# CITY OF SAVANNAH

### REQUEST FOR CERTIFICATE OF APPROPRIATENESS

**MPC File No.:** 26-002754-COA

**Address:** 412 West 40<sup>th</sup> Street

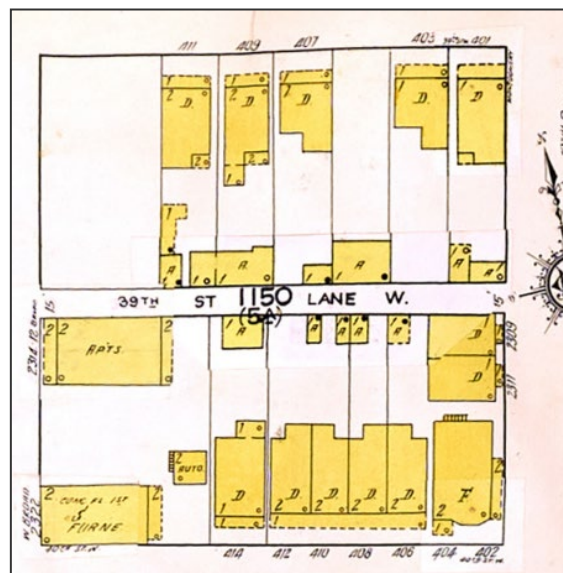
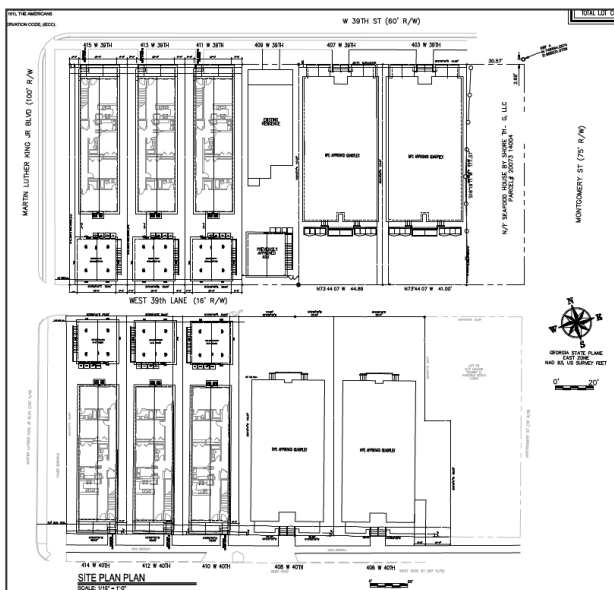
The proposed streetscape below shows the three two-story duplexes in a row similar to the Sanborn Map, bringing a sense of rhythm back to the mostly empty side of the street. As noted with the same project on West 39<sup>th</sup> Street, this is part of a larger effort to revitalize the MLK Corridor and is within an enterprise zone aiming to bring commercial and residential developments and rehabilitation back to this area.
